UNITED STATES PATENT AND TRADEMARK OFFICE

APPLICATION NO.	FILING DATE	FIRST NAMED INVENTOR	ATTORNEY DOCKET NO.	CONFIRMATION NO.
09/806,031	03/26/2001	Rabah Arhab	1200.465	3435

Office Action Summary

DETAILED ACTION

Fig. 8

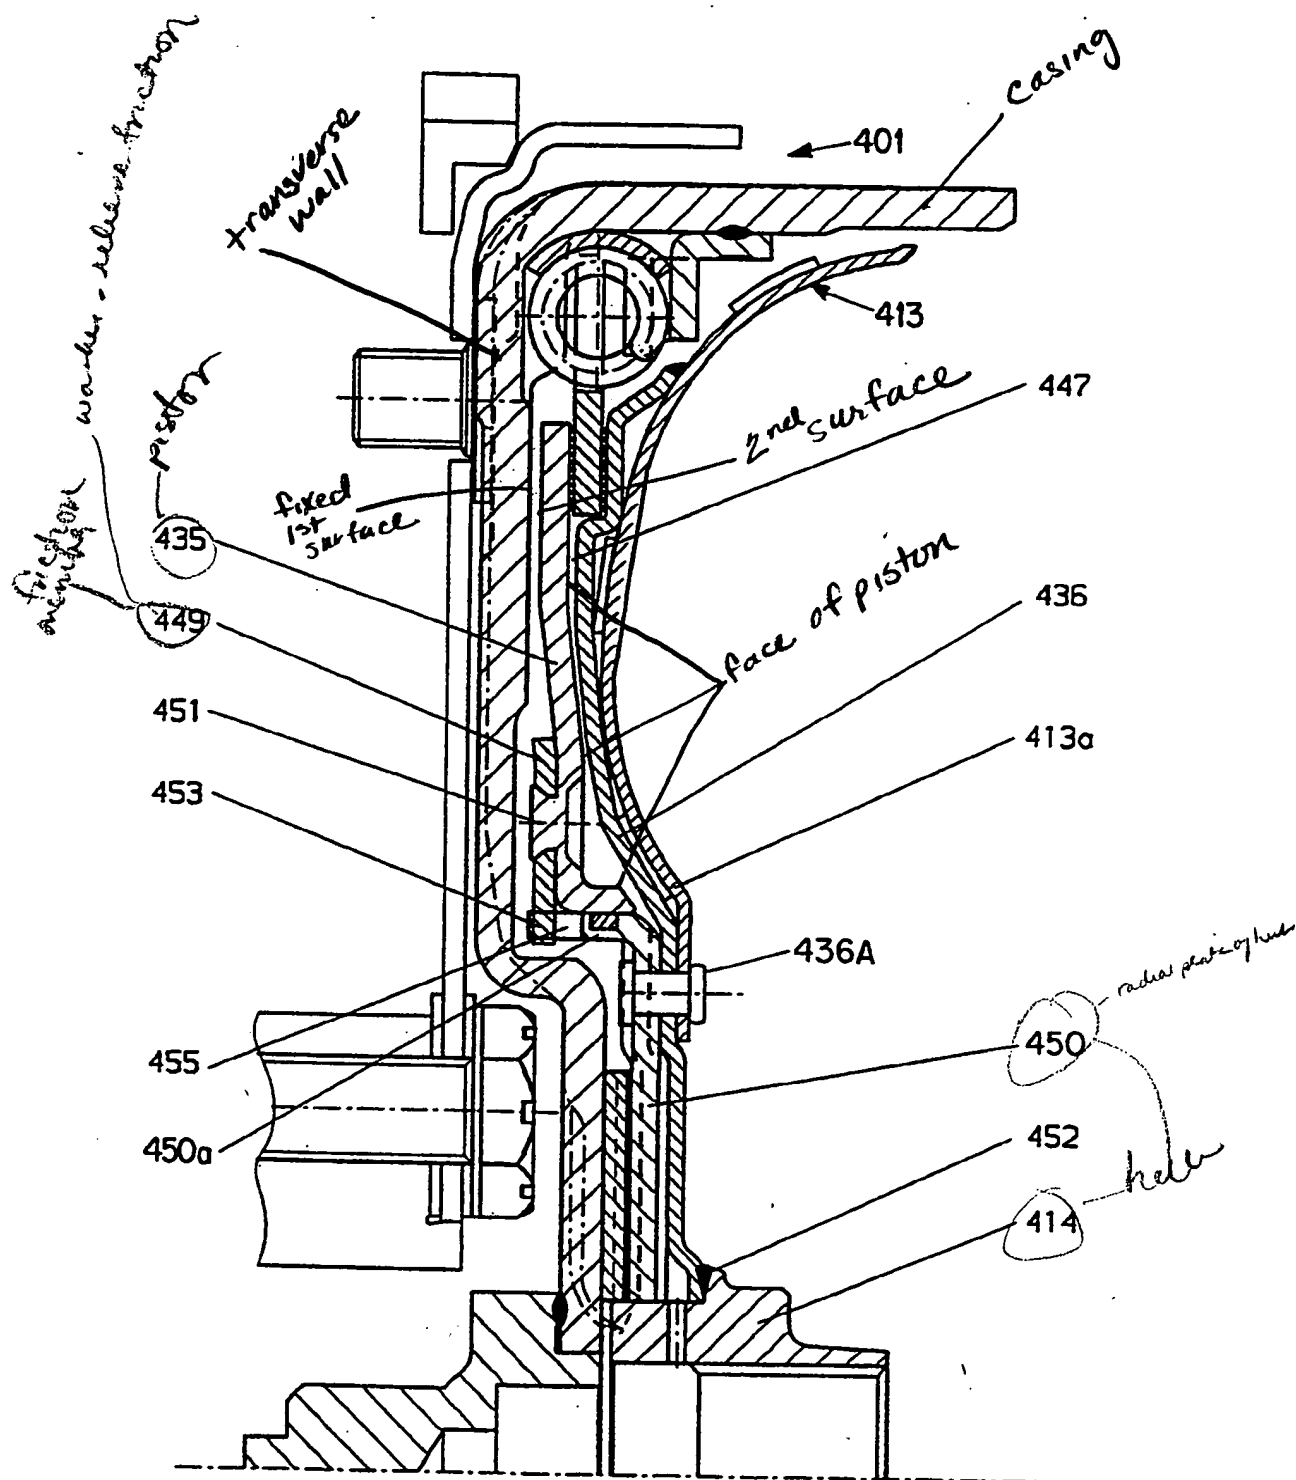
Re: claims 1, 2, 5 and 20. Friedmann et al. show in figure 8 a hydrokinetic coupling apparatus for a motor vehicle comprising a casing as labeled by Examiner in attached copy of figure 8 having a transverse wall as labeled and adapted to be coupled in rotation to a driving shaft, a turbine wheel 413 mounted within the casing and fixed to a hub 414,450 which is adapted to be coupled in rotation to a driven shaft, a fixed first surface as labeled on the transverse wall of the casing, and a lock-up clutch as shown

interposed between the turbine wheel and the transverse wall and comprising a piston 435 carrying a second surface as labeled which lies facing the first surface capable of coupling it releasably to the transverse wall as the piston reciprocates axially, wherein a friction means 449 acts between a face of the piston as labeled opposed to the second surface and an element situated in facing relationship, characterized in that the piston is so configured as to carry the friction means as shown via element 451.

Re: claims 8, 9, 10, and 11. Friedmann et al. show rivet means 451 interposed between the friction means and the piston.

Re: claims 26, 27, and 28. Friedmann et al. show in figure 8 a hydrokinetic coupling apparatus for a motor vehicle comprising a casing as labeled by Examiner in attached copy of figure 8 having a transverse wall as labeled and adapted to be coupled in rotation to a driving shaft, a turbine wheel 413 mounted within the casing and fixed to a hub 414,450 which is adapted to be coupled in rotation to a driven shaft, a fixed first surface as labeled on the transverse wall of the casing, and a lock-up clutch as shown interposed between the turbine wheel and the transverse wall and comprising a piston 435 carrying a second surface as labeled which lies facing the first surface capable of coupling it releasably to the transverse wall as the piston reciprocates axially, wherein the turbine wheel 413 includes an annular ring 413a which may be of divided form as best understood and which is fixed to the hub by means of a rivet 436a, and wherein a friction means 449 acts between the hub and the piston, characterized in that the piston is so configured as to carry the friction means as shown via element 451.

17. Claim 15 is rejected under 35 U.S.C. 102(b) as anticipated by or, in the alternative, under 35 U.S.C. 103(a) as obvious over Friedmann et al. Friedmann et al. shows in figure 8 the friction means located over a projected portion of the piston to the same extent as Applicant. The reference is silent to the way in which the friction means is connected to the projecting portion, nevertheless, the patentability of this product-by-process claim is based on the product itself. Furthermore, since molding is an old and well-known method of producing a connection, burden shifts to Applicant to show an unobvious difference that would result from the claimed processes. See MPEP 2113.

Re: claim 23. Friedmann et al. show the friction means consisting of a ring or an encircling (surrounding) arrangement as shown by virtue of the hole through which the portion 451 passes.

19. Claim 2 is rejected under 35 U.S.C. 103(a) as being unpatentable over Ross in view of Friedmann et al. Friedmann et al. teach the limitation of at least one projecting element or triangular-shaped wings or claws shown above and below the line associated with element number 451 on one of the friction means or the piston engaged in a complementary hole of the other one of the elements as shown in figure 8. It would have been obvious to one of ordinary skill in the art at the time the invention was made to have modified the end of the friction means of Ross to have included at least one projecting element used to engage in the complementary hole on the piston, in view of the teachings of Friedmann et al., in order to provide a means of improving the retention of the two elements.
